**RE: Docket No. 23-37-EL – The Narragansett Electric Company d/b/a
Rhode Island Energy’s Petition for Acceleration of a System Modification
Due to Distributed Generation Project
Tiverton Project
Responses to Division Data Requests – Set 2**

The Narragansett Electric Company
d/b/a Rhode Island Energy
RIPUC Docket No. 23-37-EL
In Re: Rhode Island Energy's Petition for Acceleration Due
To Distributed Generation Project – Tiverton Projects
Responses to the Division's Second Set of Data Requests
Issued on December 15, 2023

Division 2-3

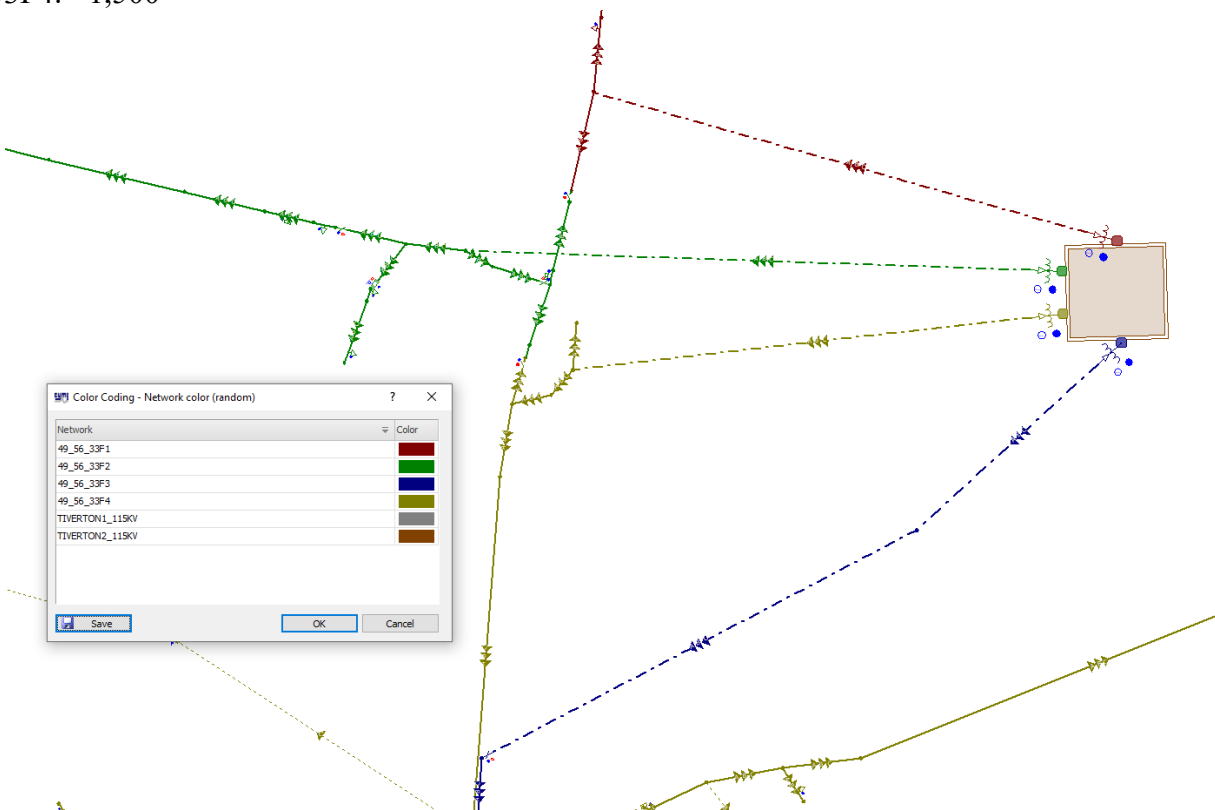
For Table 4.1 on page 160 of the filing, page 8 of 42 of the Tiverton Area Study Exhibit EJRS-3 attached to the Petition, show on a circuit diagram for each feeder what portion of the feeder is loaded to the percentage as indicated in the Table.

The portion of each feeder that would potentially be loaded to the values shown in Table 4.1, are the station underground getaways for each circuit. Below is a snapshot from CYME showing the extent of those portions. The underground portions are dashed lines, connecting to solid lines where they rise up.

- 33F1: ~1,000'
- 33F2: ~1,500'
- 33F3: ~2,500'
- 33F4: ~1,500'
